City of Portland
 Development Review Application
 Planning Division Transmittal form

Project Name: 267 Congress St.; Conditional Use and Site Plan

Project Description: Conditional Use for Chaim Synagogue Single Story Addition & Exterior stair addition

Subject: Application ID: 2012-556

FIRST FLOOR LIFE SAFETY PLAN

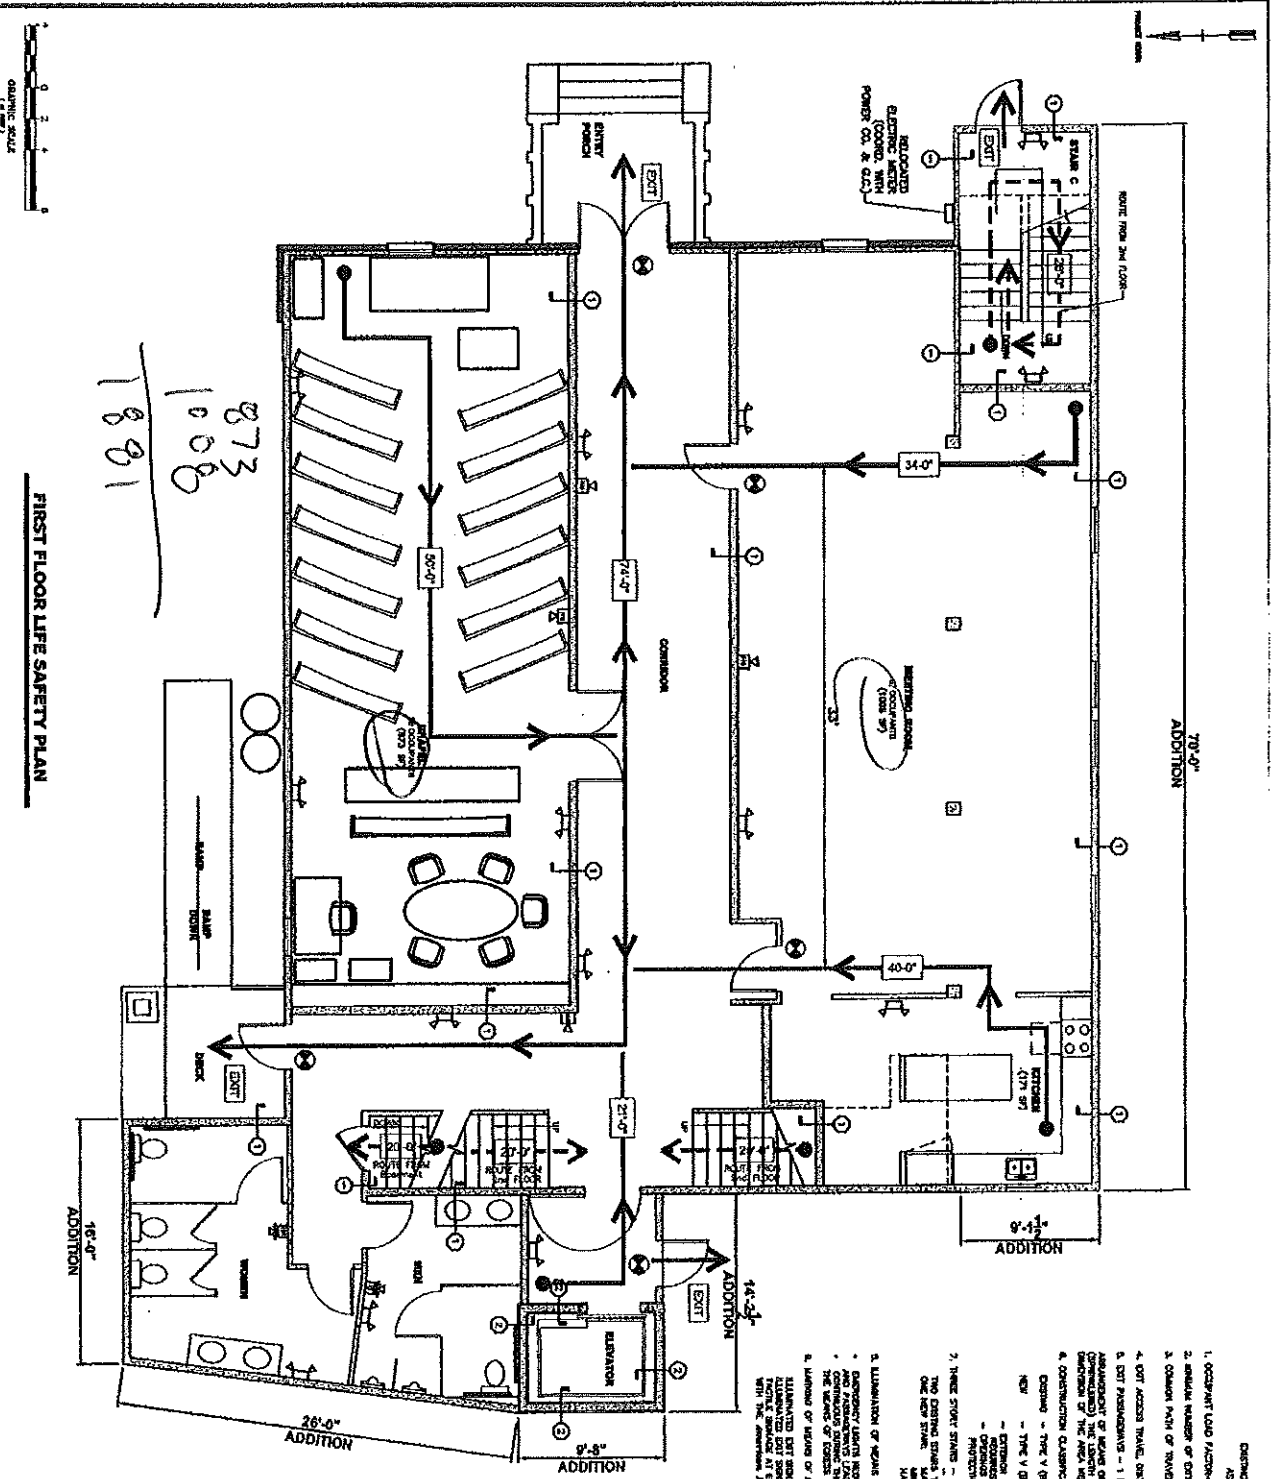
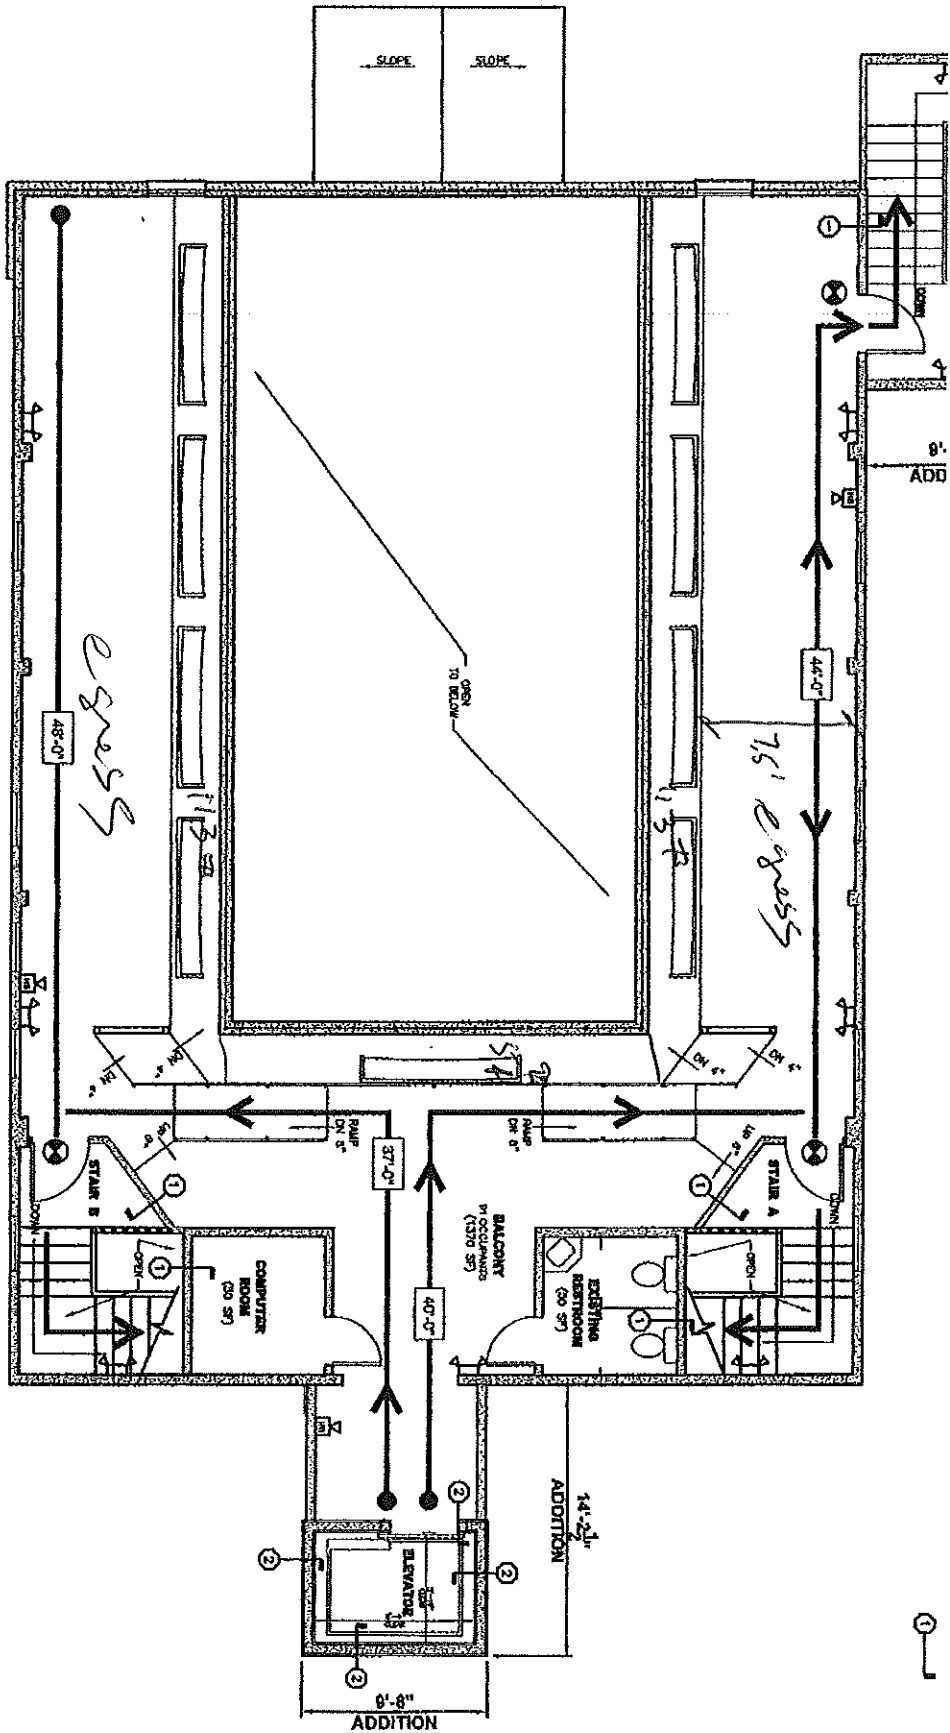
1st floor
 most current printed 2/15/13

1881
 1535
 280
 3696
 Assembly Room

ETZ CHAIM SYNAGOGUE
 267 CONGRESS STREET
 PORTLAND, MAINE
 SECOND FLOOR PLAN

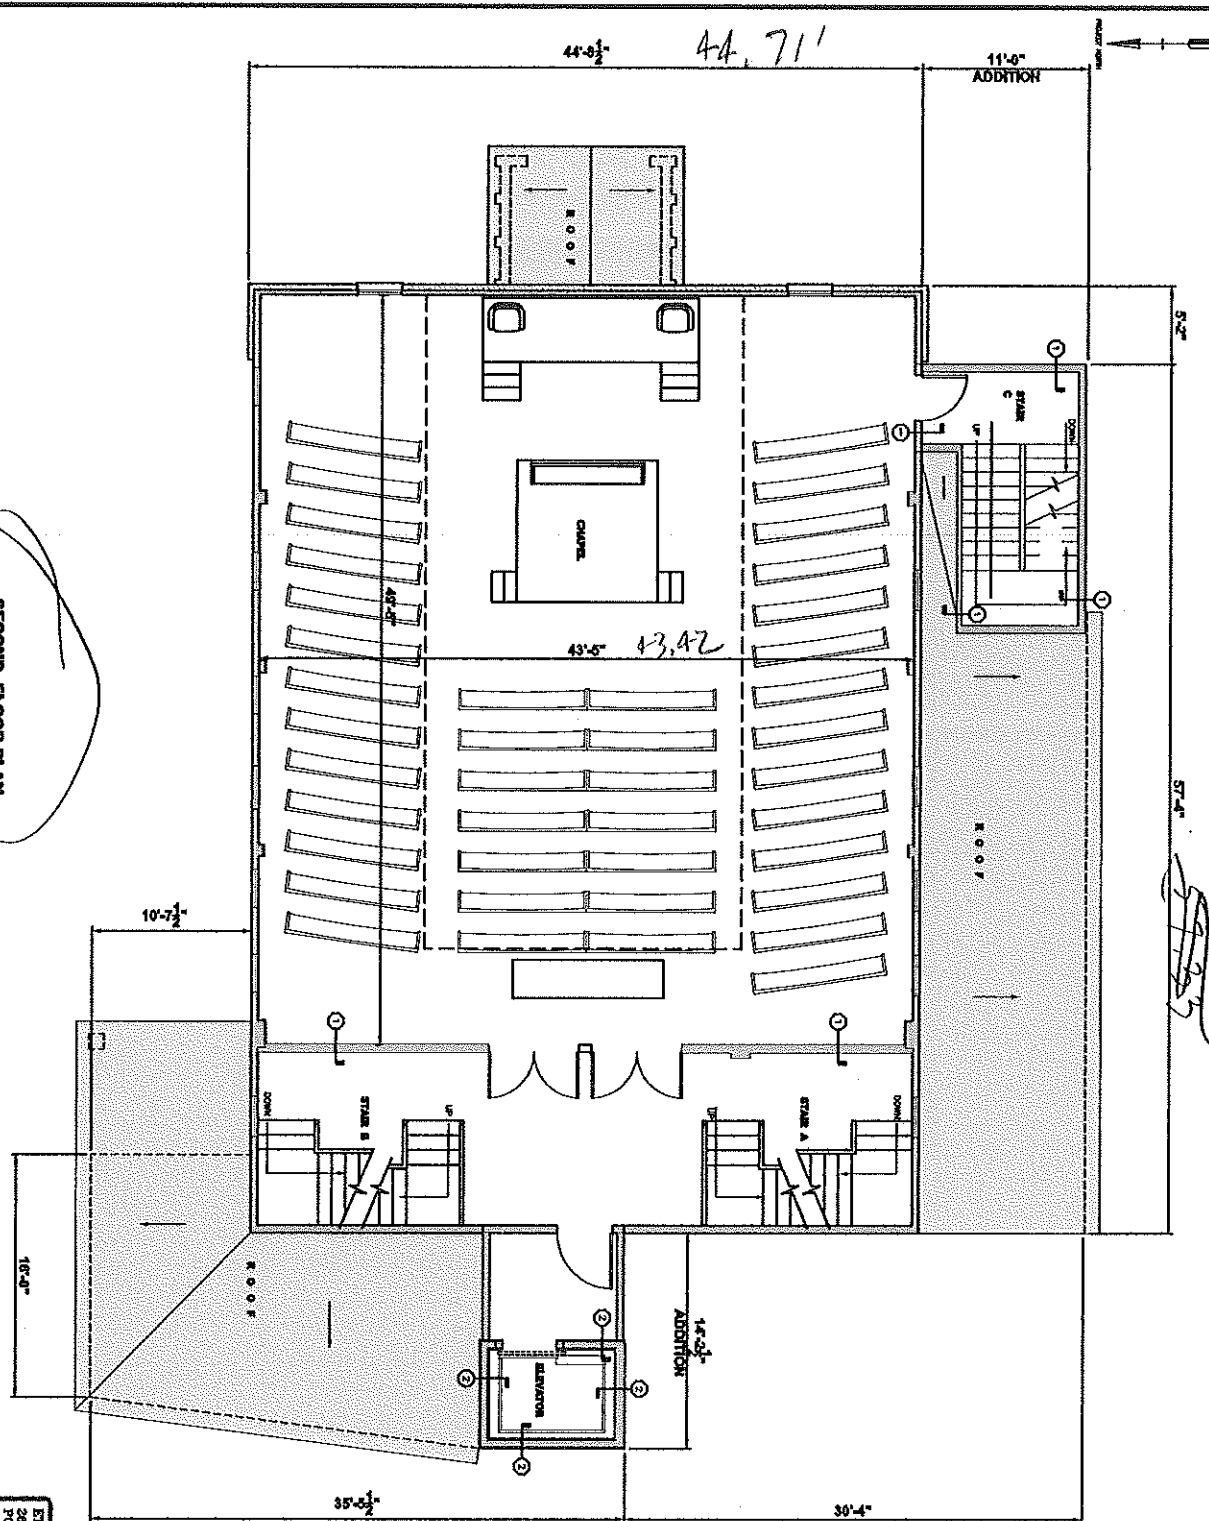
~~44.71 x 57.33~~

43.42 x 49.42

2nd floor 2145.82 sq ft
